1976/62. Investigation of a proposed subdivision at Upper Scamander.

At the request of the regional health inspector an inspection was made of a proposed subdivision of land owned by Mr J. Wigram at Upper Scamander [FQ032086].

# PROPOSED SUBDIVISION - J. WIGRAM - UPPER SCAMANDER

Figure 1.

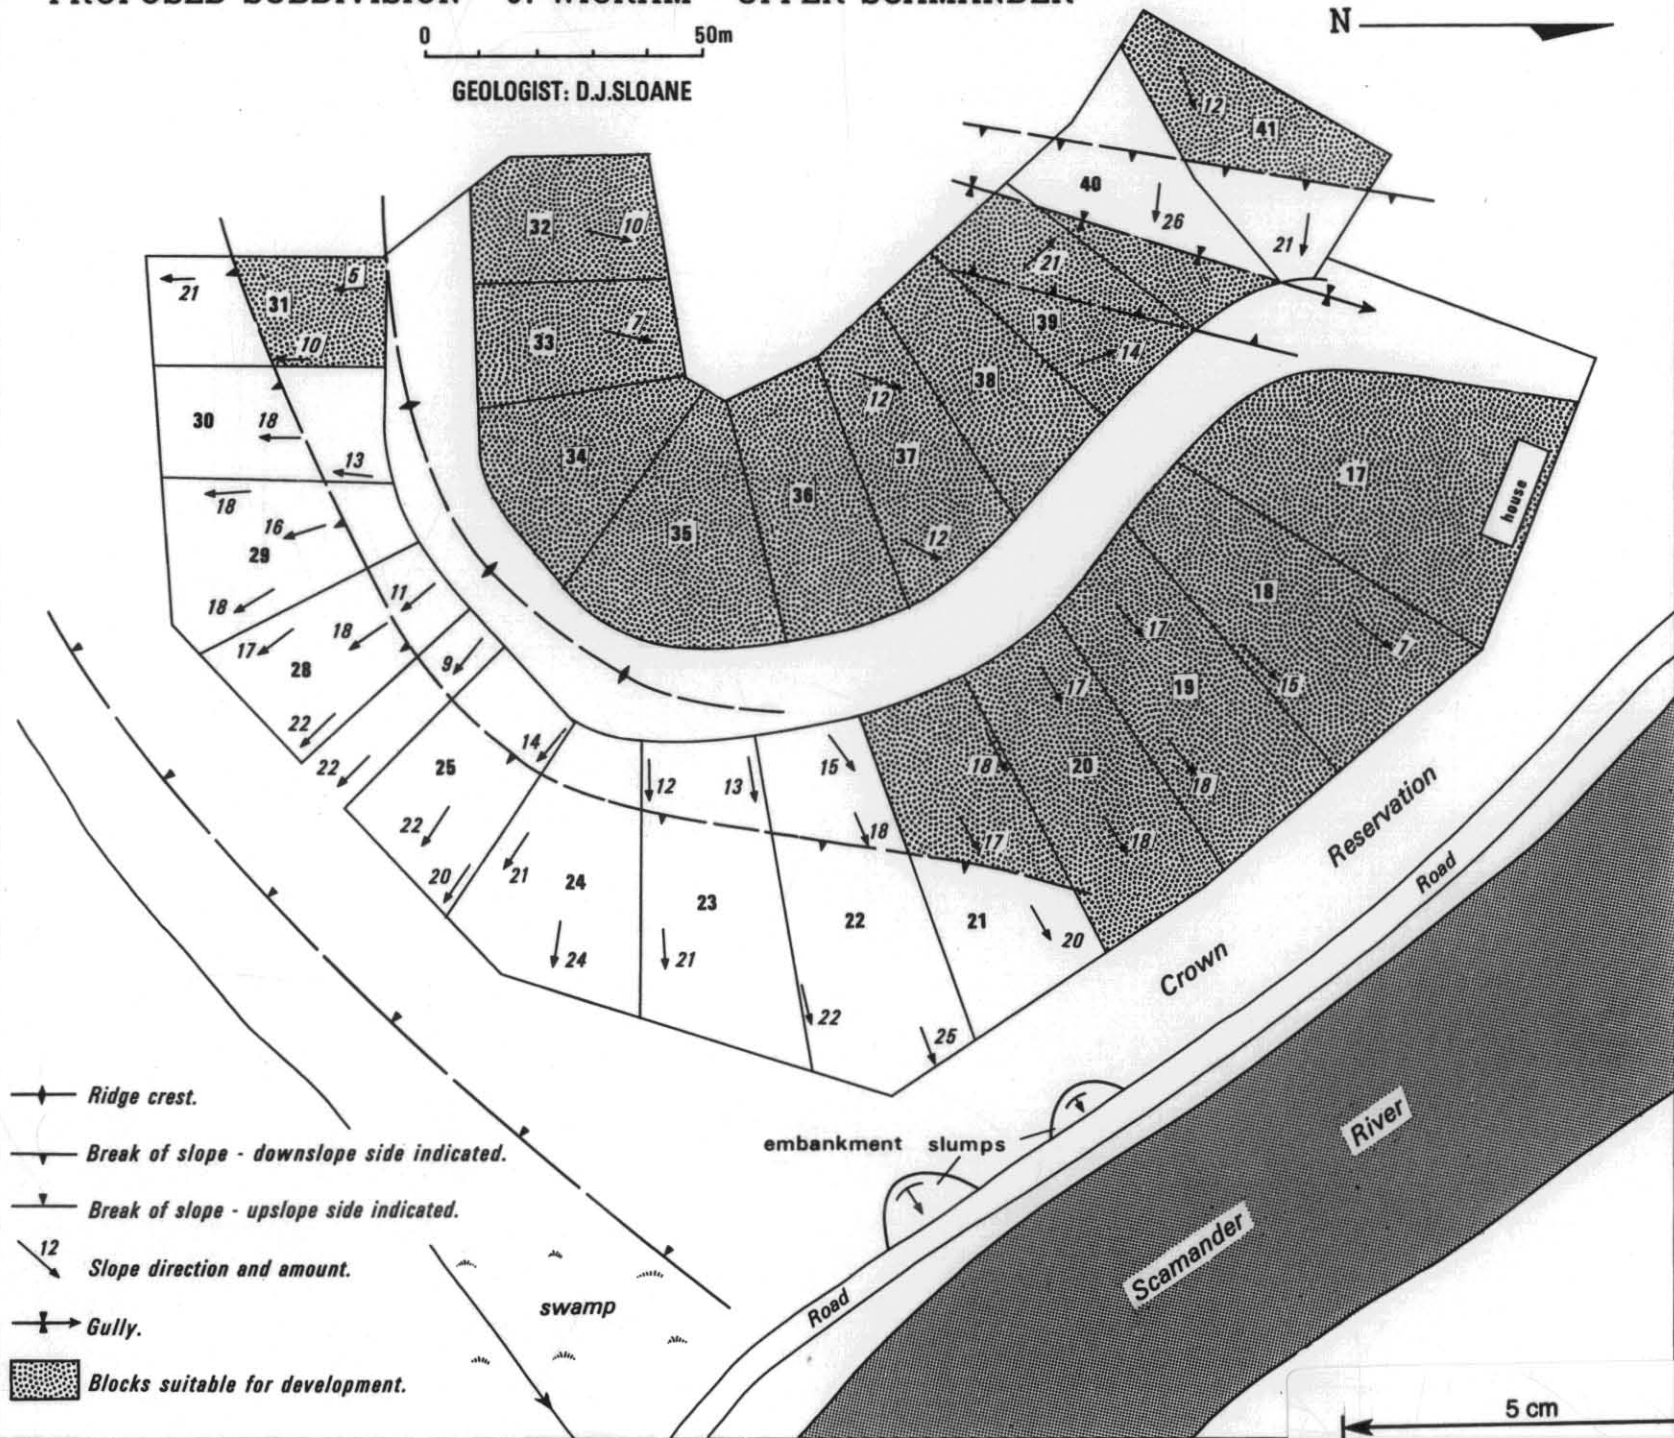
The accompanying map (fig. 1) shows the general topography of the subdivision site. To the south and east slopes are moderate to steep (18-24°) from a ridge crest along the proposed subdivision road towards the Upper Scamander road to the east and a low-lying swampy area to the south. Slopes in the northern and western section of the subdivision are moderate to gentle (7-17°). A large gully crosses blocks 39, 40 and 41; slopes here are about 20-25°.

The factors described above indicate potential instability of the south-eastern area of the subdivision and the sides of a gully to the north-west. The threshold of stability for development is considered to be a slope of 18°. Therefore blocks 22, 23, 24, 25, 28, 29, 30 and 40 are considered unsuitable for development. Blocks 21, 31, 39 and 41 are considered

suitable *only* if building is conducted in the shaded portion of the blocks on the accompanying map; except for block 41, buildings should be sited as close as possible to the subdivision road.

If the subdivision road were to be re-located 15 m further west blocks 22-30 could be considered suitable for development. Although this would probably necessitate fewer building blocks on the western side of the road, all seven blocks on the eastern side could then be developed. If the layout of the subdivision is altered, a re-inspection by a geologist from this department would be necessary.
